HYDRO ONE INTERROGATORIES (REVISED 2022-02-04)

M-HYDRO ONE-1

Reference: Exhibit M, Page 7 and Curriculum Vitae

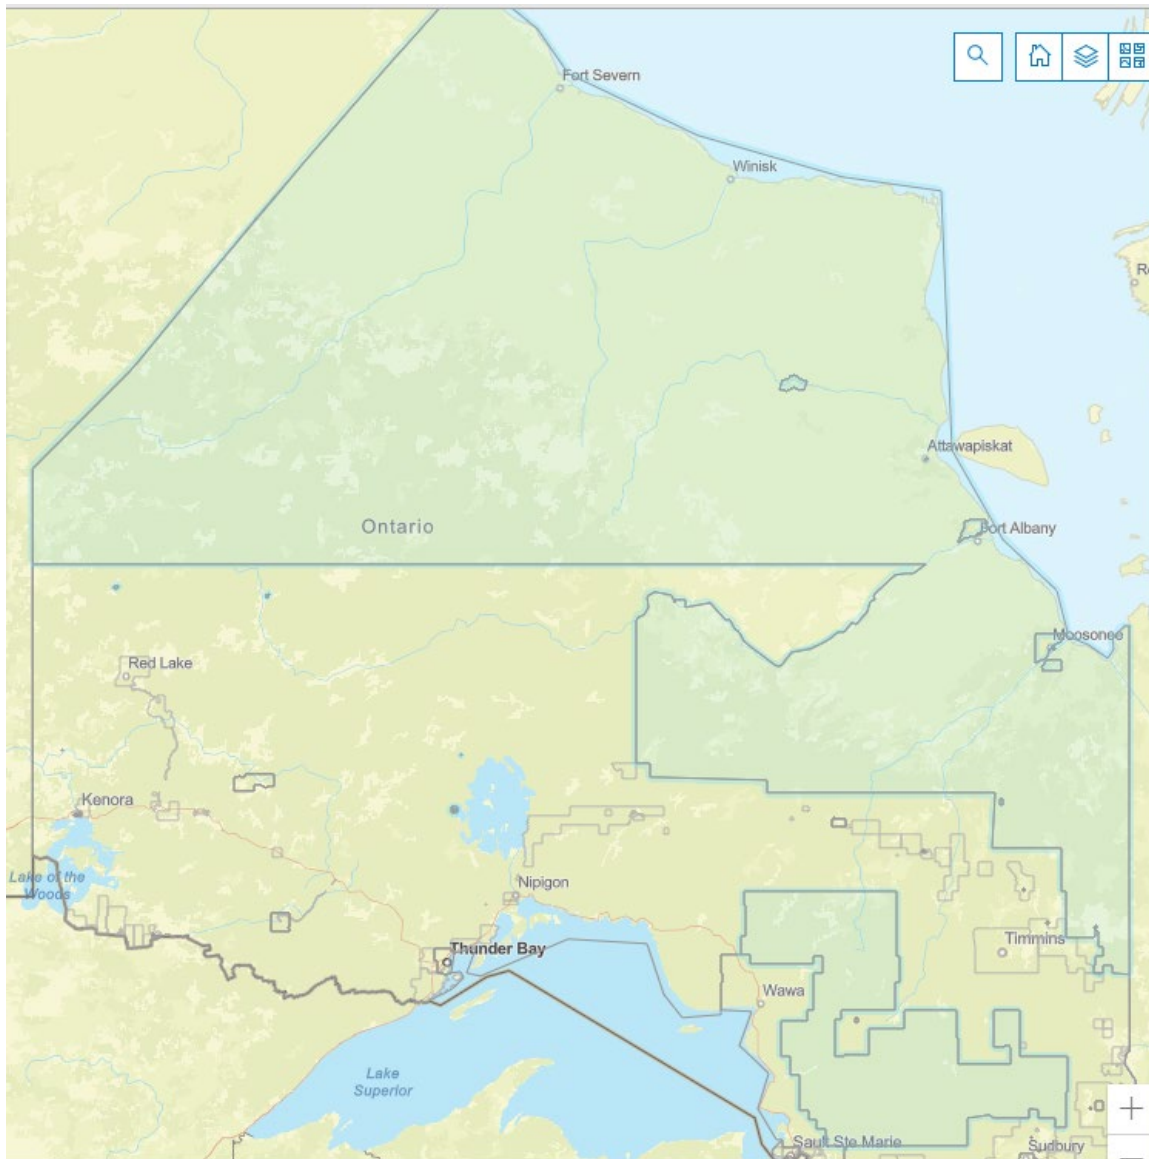
- c) Did PEG take any steps at all to pursue estimating what it would consider a more accurate or suitable service area estimate for Hydro One's service territory? If so, please advise what steps were taken and what preliminary results were obtained and provide copies of any material indicating the work PEG did and the results of it. If PEG did not do so, please explain why?

In the current proceeding, PEG examined the official service territory maps provided on the OEB website Ontario Electricity and Natural Gas Utilities - Service Area Map | Ontario Energy Board (oeb.ca) and considered their use to obtain a better estimate of the service territory actually served by Hydro One Distribution. PEG was unable to find a straightforward way to do this from these maps. Their review revealed that vast areas of Ontario are lightly populated and unserved by any distributor. PEG attempted to determine what land area their previous area estimate would cover to determine if it contained very large unserved areas.

1. Hydro One currently reports an area of 961,498, which is significantly higher than the area reported by the Company in 2014. A possible explanation for the large difference between these values is that the area that Hydro One Remote Communities stands ready to serve was not reported in the earlier OEB Electricity Yearbook and that this area is included in the more recent and higher area estimates.
2. The current Hydro One RRR value versus what PEG used in the Hydro Ottawa proceeding implies that the size of Hydro One Remote Communities service territory is about 300,000 square kilometers. This seems plausible from looking at the maps.
3. If this is the case, then the Hydro One service territory on the OEB map has an area of around 650,000 sq. km.

Comparing Lines and Area as Dispersion Variables

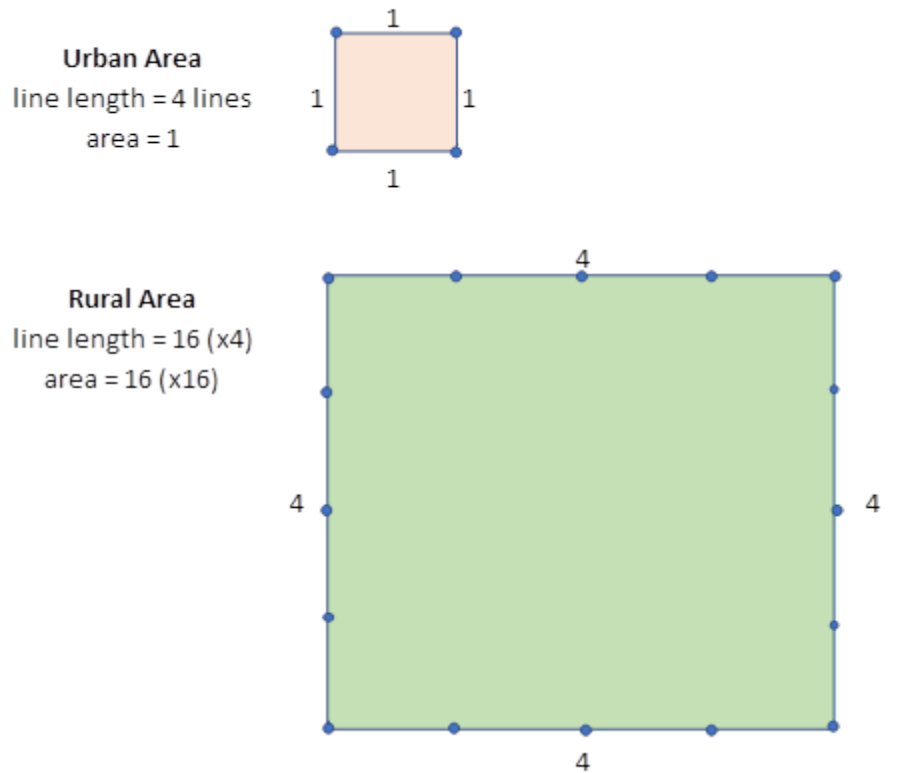
- j) Please confirm that Hydro One's distribution total cost benchmark score improves by approximately 27% if instead of transmission line lengths, PEG uses the distribution land area variable that it used in its Hydro Ottawa research (all else being equal, with no other methodological changes). If not confirmed, please provide an estimate of the impact along with details explaining the calculation including the model used to estimate the impact of moving to transmission line miles from distribution land area.

This analysis suggests that, whereas area is a useful measure of dispersion in the absence of line length data, and is doubtless positively correlated with line length, its use in benchmarking would tend to favor utilities that serve rural areas more than urban areas.

It is also noteworthy that, in PEG's distribution total At this juncture, the question naturally arises as to whether transmission line miles or licensed service territory area have more explanatory value as a driver of distribution cost. In PEG's total distributor cost research they found that the transmission line length variable had an estimated cost elasticity that was a little higher than that for the ClearspringClearspring's area variable if the latter variable was used as an alternative. The t statistic on the transmission line length variable was a little lower but still indicative of high significance. In runs where both variables were included in the same model both of the parameter estimates had high statistical significance. Thus, area and transmission line length were found to be similarly
